FINAL AGENDA

Community Zoning Appeals Board 15
Naranja Park, 14150 SW 264 Street, Miami, FL
Wednesday, April 9, 2025 at 6:30 pm

A. RICADRI GROUP, LLC. Z2023000545

**Miami-Dade County Department of Regulatory and Economic Resources
Staff Report to Community Zoning Appeals Board No. 15**

SITE PLAN

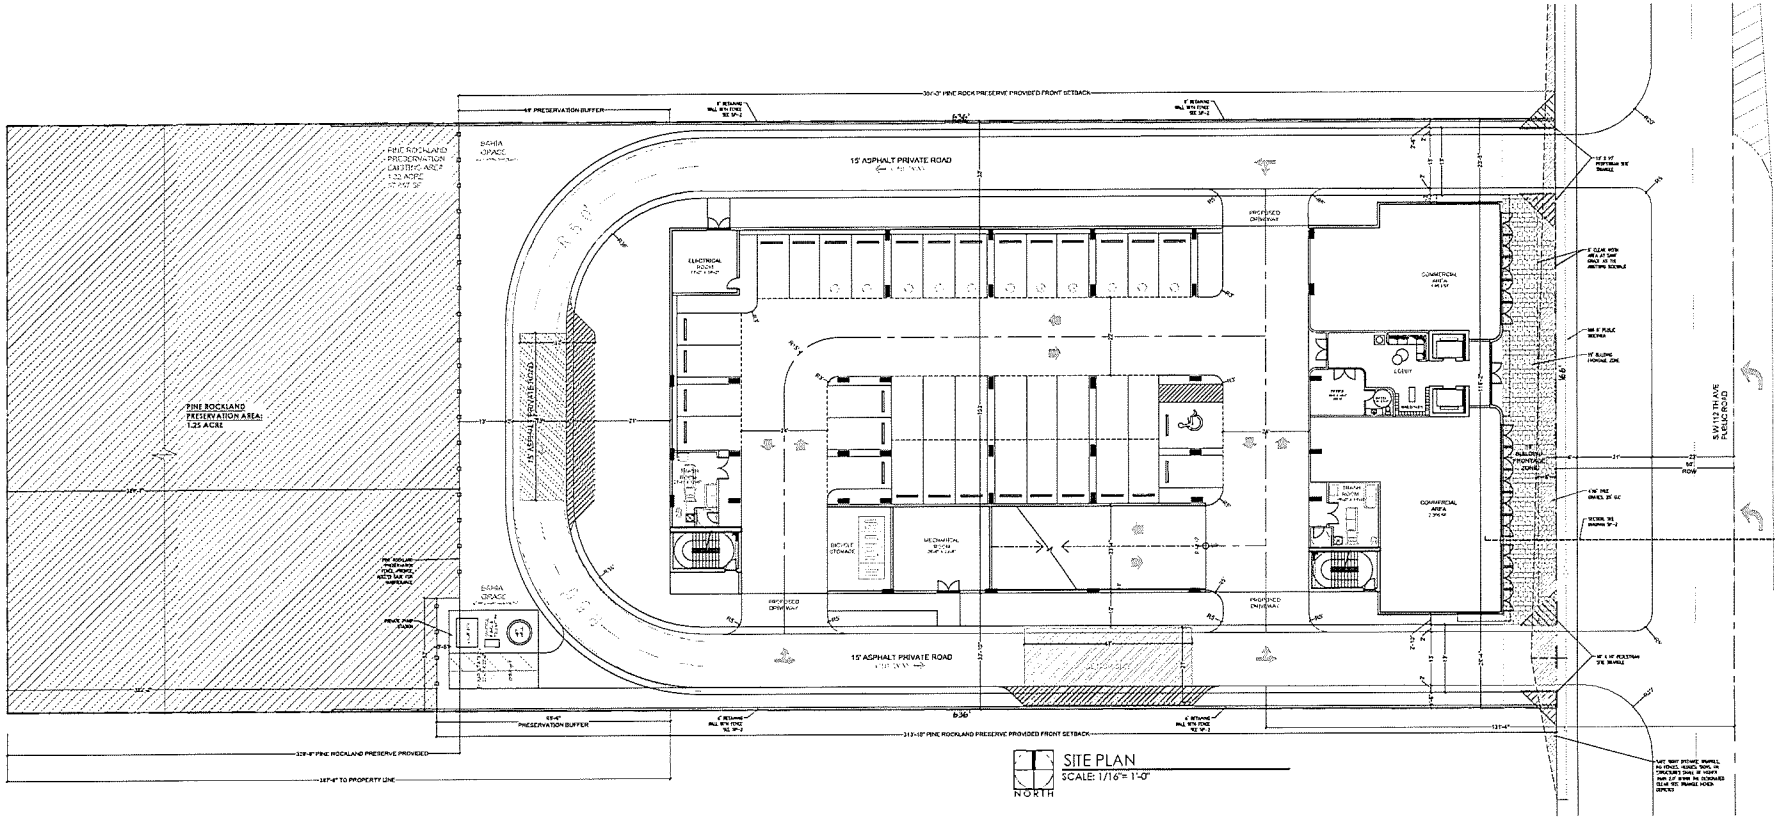
- Please provide an updated Site Plan to **include the Open Space Requirements Diagram** and calculations, detailing proposed versus required Open Space
- PROS recommends that the applicant **provides additional private recreational amenities to the development and its residents as space allows**. PROS recommends elements such as pet relief stations on the ground floor, shaded seating areas, picnic tables, grills, walking amenities, and play area.
- **Provide an updated Landscaping Plan** that shows the proposed landscape design on to the Pool Deck, 4th Level Floor Plan.
- PROS recommends **adding shade trees, along all pedestrian walkways, and leisure areas of the development**, for example on the Pool Deck, to provide a more shaded and walkable

21320 SW 112 AVE
 MIAMI DADE COUNTY
 LANDSCAPE PLAN

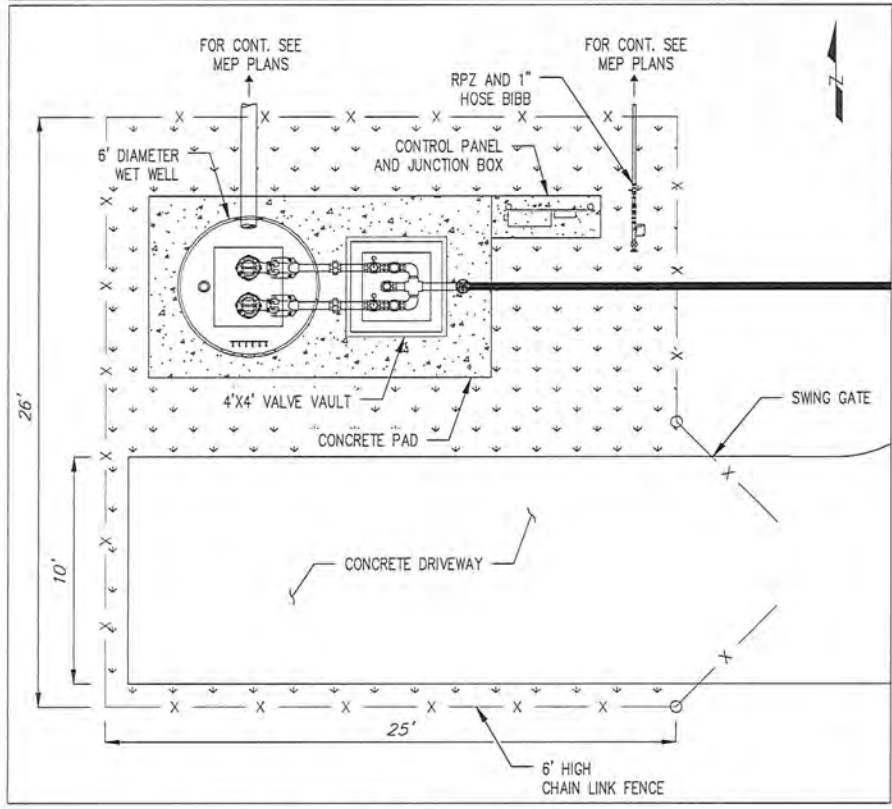
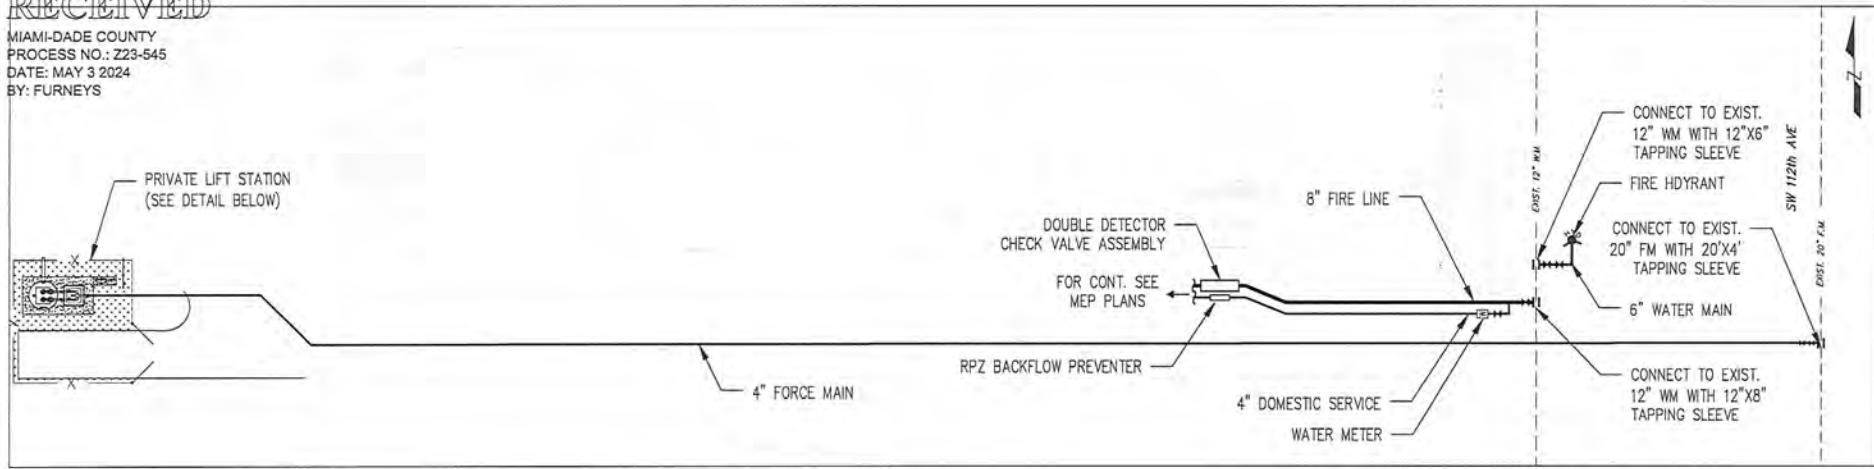
DERM has reviewed the landscape plan entitled “21320 SW 112 AVE” and dated as received by Miami-Dade County on October 15, 2024, in support of this zoning application and acknowledges it correctly identifies and labels the “Pine Rockland Preserve” with the correct acreage of 1.25 acres. In addition, the landscape plan has been amended with the appropriate native species *Zamia integrifoli*. However, the site plan submitted with this application does not contain information regarding the specimen trees within the proposed development area. DERM cannot determine that this project complies with the requirements of sections 24-49.2 and 24-49.4 of the Code, specifically the specimen tree standards. Please note that the Code generally requires the preservation of specimen trees and the standards in the Code for removal/relocation of specimen trees are stricter than for removal of a non-specimen trees. Additionally, Tree removal permit application #2400390 was submitted April 26, 2024, but this permit has not been issued yet. DERM Staff has determined that the removal of the specimen trees is allowed pursuant to section 24-49.2(II) of the Code. DERM has no objection to this application provided that the applicant obtains this tree permit and that all conditions of the tree permit are adhered to once it is issued.
